**GLENORCHY PLANNING AUTHORITY  
ATTACHMENTS  
MONDAY, 21 MARCH 2022**

<b>5.</b>	<b>PLANNING SCHEME AMENDMENT TO REZONE 60, 80, 80A &amp; 90 CREEK ROAD, NEW TOWN TO AN INNER RESIDENTIAL ZONE AND CONSOLIDATE THE LOTS</b>	
1:	PLAM-21 04 Attach 1 - Amendment .....	2
2:	PLAM-21 04 Attach 2 - Subdivision Plans.....	8
3:	PLAM-21 04 Attach 3 - Taswater Referral.....	9
<b>6.</b>	<b>AMENDMENT PLS43A-21/03 - S.40K REPORT ON REPRESENTATIONS</b>	
1:	PLS43A-21 03 Attach 1 - Draft SAP (Post-exhibition modifications).....	12
2:	PLS43A-21 03 Attach 2 - Draft Permit (Revised March 2022).....	17

**GLENORCHY LOCAL PROVISIONS SCHEDULE  
AMENDMENT PLAM-21/04**

**GLE-S13.0** 263, 271 and 295 Main Road, Austins Ferry Specific Area Plan**GLE-S13.1** Plan Purpose

Image 1 – Land to be included in an Inner Residential Zone

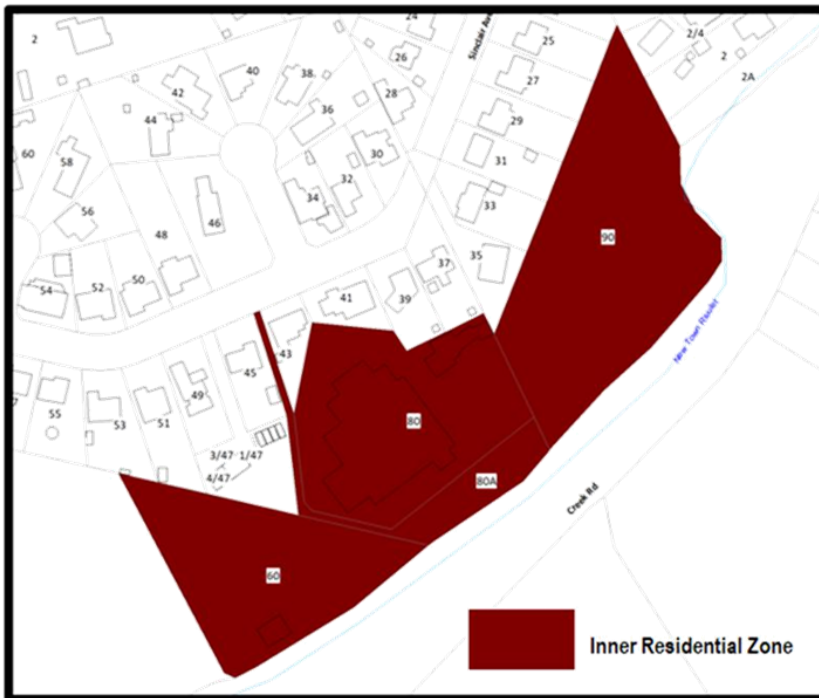
1. Modifying the zoning maps to include 60, 80, 80A and 90 Creek Road, New Town in an Inner Residential Zone as shown in Annexure 1 - image 1.
2. The zoning maps are overlayed to show the area of GLE-S14.0 - 60, 80, 80A and 90 Creek Road, New Town Specific Area Plan as shown in Annexure 1 - image 2.

Figure GLE-S13.1

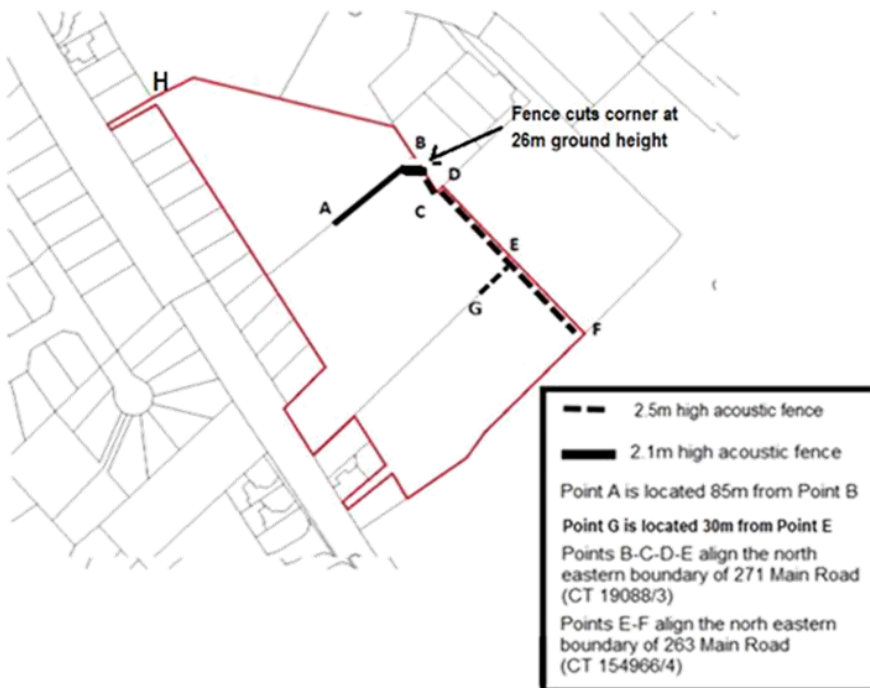
<p>1/1-octave band and above must be constructed at the height and location shown in Figure GLE-S13.1</p> <p><b>A1.2</b></p> <p>For new dwellings at 295 Main Road, Austins Ferry there is no acceptable solution.</p>	<p>(a) the nature of neighbouring noise sources and potential noise sources;</p> <p>(b) the distance to neighbouring noise sources;</p> <p>(c) the particular shape, contours or slope of the subject land, or of adjoining land;</p> <p>(d) the construction of any contiguous mass barrier with a sound transmission loss of 20 dB or more at frequencies from the 125 Hz 1/1-octave band and above on the site;</p> <p>(e) the location of any existing buildings on the site that may mitigate noise from neighbouring noise sources;</p> <p>(e) the type of building construction;</p> <p>(f) the siting of habitable rooms;</p> <p>(g) the siting of outdoor open spaces areas, decks or balconies; and</p> <p>(h) the ability for all habitable rooms in the area shown in Figure GLE-S13.2 to meet AS2107:2016 – <i>Acoustics (Recommended Design Sound Levels and Reverberation Times for Building Interiors)</i></p>

<p><b><u>A2</u></b></p> <p><u>No private open space or dwelling, excluding garages, carports or accessways, is located within 10m of the northern boundary of 295 Main Road Austins Ferry between points B and H shown in Figure GLE-S13.1.</u></p>	<p><b><u>P2</u></b></p> <p><u>No performance criterion.</u></p>
<p><b><u>A2A2</u></b></p> <p>For <del>new</del> dwellings of two or more storeys located in the area shown in Figure GLE-S13.2, an assessment by a suitably qualified acoustic engineer is required to demonstrate all habitable rooms are designed to meet <i>AS2107:2016 –Acoustics (Recommended Design Sound Levels and Reverberation Times for Building Interiors)</i>.</p>	<p><b><u>P2P3</u></b></p> <p>An assessment by a suitably qualified acoustics engineer must show that the occupants of buildings intended for residential uses are provided with a satisfactory noise environment, taking into account all of the following:</p> <p>(a) the nature of neighbouring noise sources;</p> <p>(b) the distance to neighbouring noise sources;</p> <p>(c) the particular shape, contours or slope of the subject land, or of adjoining land;</p> <p>(d) the type of building construction; and</p> <p>(e) the siting of habitable rooms.</p>

Figure GLE-S13.2

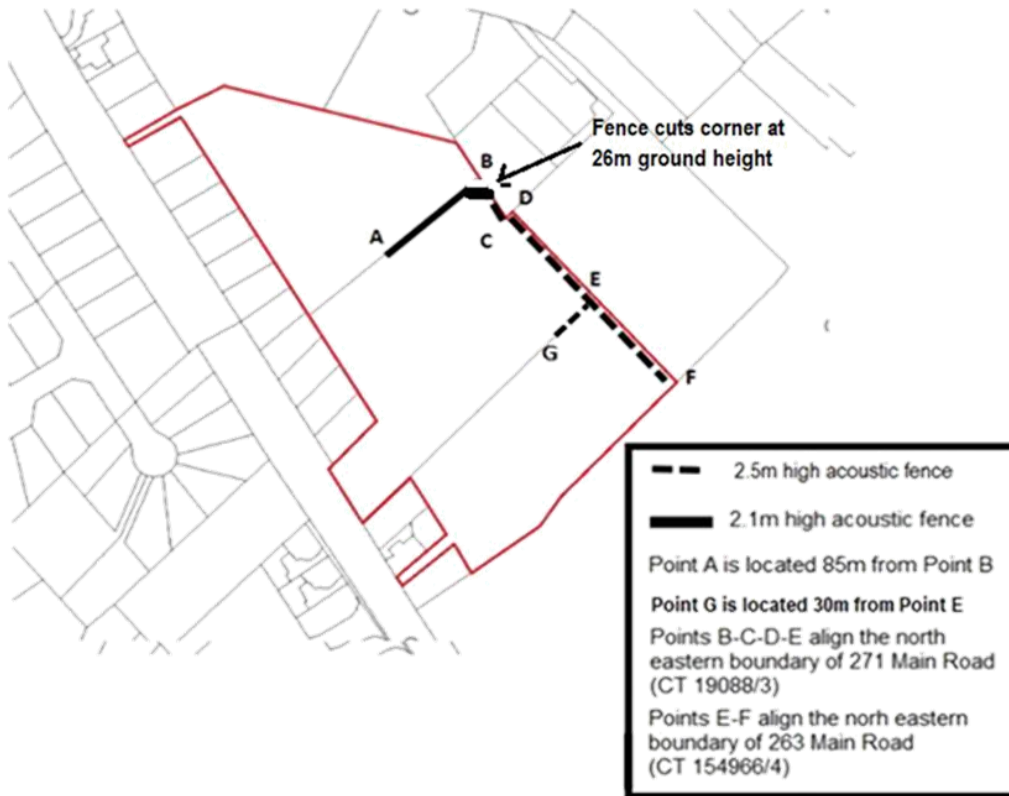
<p><b><u>A3A4</u></b></p> <p>Second storey and above deck and balcony spaces of <del>new</del> dwelling located in the area shown in Figure GLE-S13.2</p>	<p><b><u>P3P4</u></b></p> <p>An assessment by a suitable qualified acoustics engineer must show that the occupants of buildings intended for residential uses are provided with a</p>
